NINE MILE POINT NUCLEAR STATION

SUBJECT: Nine Mile Point Nuclear Station, Unit 2
Renewed Facility Operating License No. NPF-69
Docket No. 50-410

License Amendment Request Pursuant to 10 CFR 50.90: Maximum Extended Load Line Limit Analysis Plus

Figure 3.1.7-1 (Page 1 of 1)
Sodium Pentaborate Solution Volume/Concentration Requirements

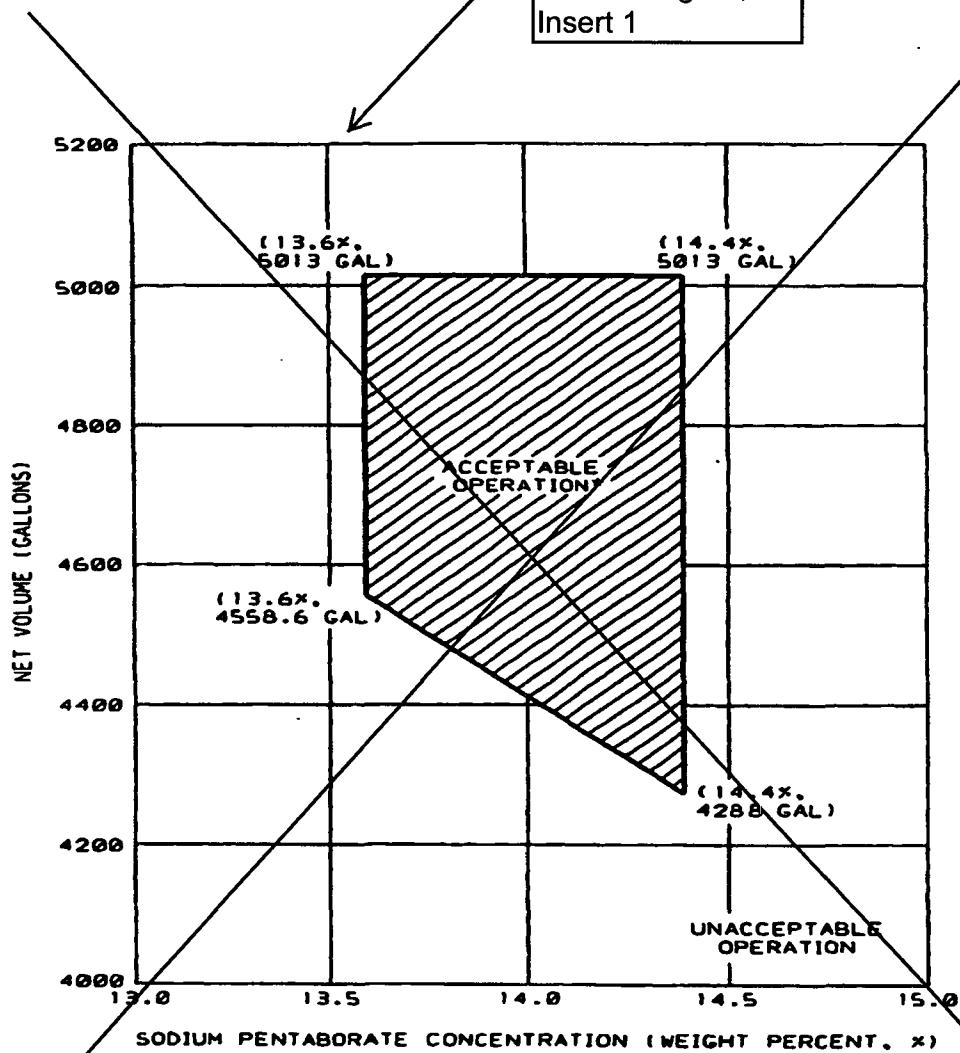
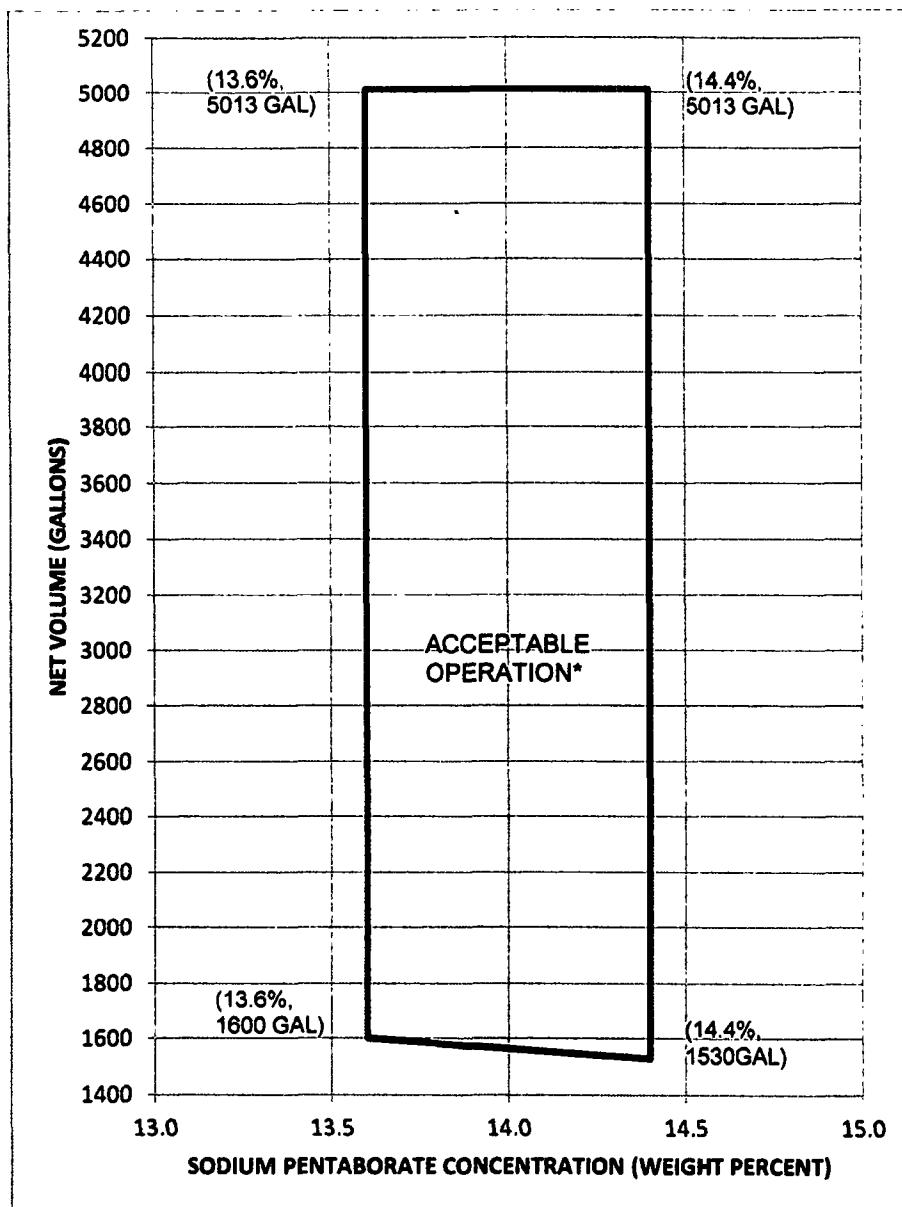
TS Figure 3.1.7-1, "Sodium Pentaborate Solution Volume/Concentration Requirements," is revised to account for the change in the net volume in the SLS tank that arises from the enrichment increase. The minimum volume is changed from 4,558.6 gallons and 4,288 gallons at sodium pentaborate concentrations of 13.6% and 14.4%, respectively, to 1,600 gallons and 1,530 gallons at a sodium pentaborate concentration of 13.6% and 14.4%, respectively.

Replace with
attached figure,
Insert 1

TS Insert 1 - Figure 3.1.7-1

Figure 1: Integrated SRV Flow

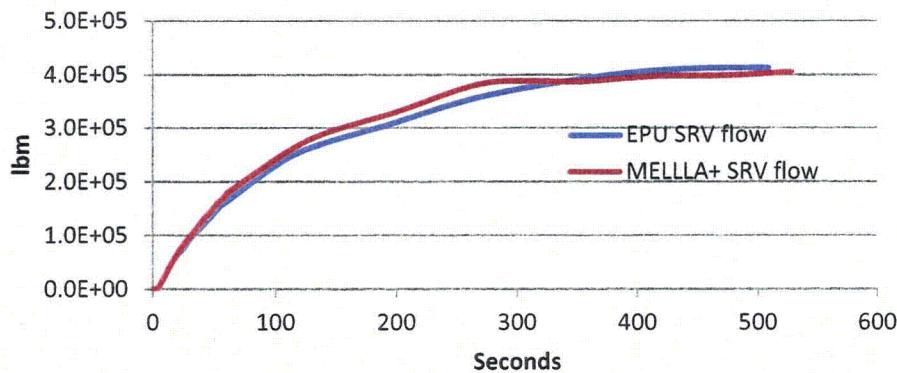
- A comparison between the EPU ATWS analysis and the MELLLA+ ATWS analysis indicates that the integrated SRV flow is about the same. For example, a comparison with MSIVC (all MSIVs close initiating event) for the end of cycle indicated the integrated flow is similar for the first minute, MELLLA+ is slightly higher between 1 and 5 minutes and then MELLLA+ integrated flow is less than EPU from 5 to 10 minutes due to the higher boron enrichment which results in slightly quicker shutdown (confirmed by neutron flux comparison). See Figure 1 below.
